Access Compliance Report

Public Rights-of-Way

(Curb Ramps)

Intersection ID: 18857	Main Street: FOX_RUN_DR	Cross Street: MONROE_RD	Location: NW
ADA ID: 1FE0E1F320E6	Ramp Type: PerpDiag	Initial Pass/Fail: Fail	Overall Compliance: No
		Severity Score: 50

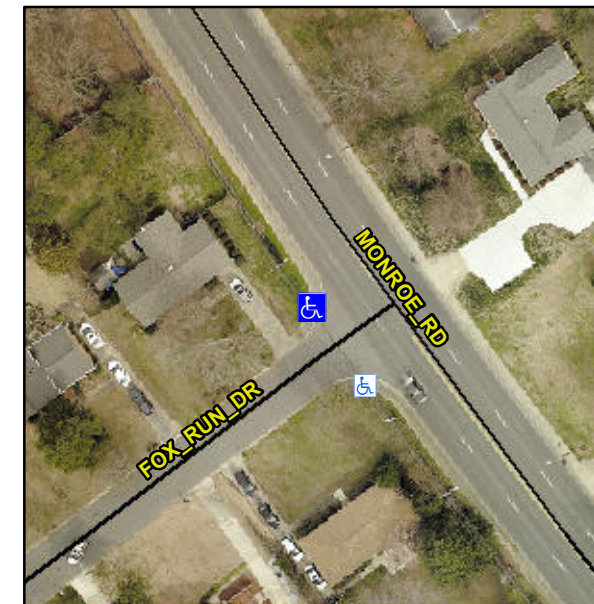
Not Found, R304.2.2, R304.5.3

Compliance	Description	Data	Compliance	Description	Data
N/A	Ramp Length (in)	59.0	No	Ramp Slope (%)	15.8
Yes	Ramp Width (in)	48.0	No	Ramp XSlope (%)	7.0
N/A	Flare Type LT	N/A	N/A	Flare Type RT	N/A
N/A	Flare Slope LT (%)	N/A	N/A	Flare Slope RT (%)	N/A
N/A	Flare Traversable LT?	N/A	N/A	Flare Traversable RT?	N/A
N/A	Landing Length (in)	N/A	N/A	DWS Provided?	N/A
N/A	Landing Width (in)	N/A	N/A	DWS Contrast?	N/A
N/A	Landing Slope (%)	N/A	N/A	DWS Length (in)	N/A
N/A	Landing X Slope (%)	N/A	N/A	DWS Full Width?	N/A
N/A	Landing Curb? (Y/N)	N/A	N/A	DWS Offset (in)	N/A
N/A	Shared Landing?	N/A			
N/A	Gutter Ponding?	N/A	N/A	Gutter Slope (%)	N/A
N/A	Gutter Lip Ht (in)	N/A	N/A	Gutter X Slope (%)	N/A
N/A	Painted X Walk1?	No	N/A	Painted X Walk2?	No
	X Walk 1 Direction	To SE		X Walk 2 Direction	To E
N/A	X Walk 1 Width (in)	N/A	N/A	X Walk 2 Width (in)	N/A
	X Walk 1 Slope (%)	1.9		X Walk 2 Slope (%)	4.1
	X Walk 1 X Slope (%)	5.8		X Walk 2 X Slope (%)	2.1

Remove & Replace Curb Ramp With Two New Directional Ramps or Equivalent.
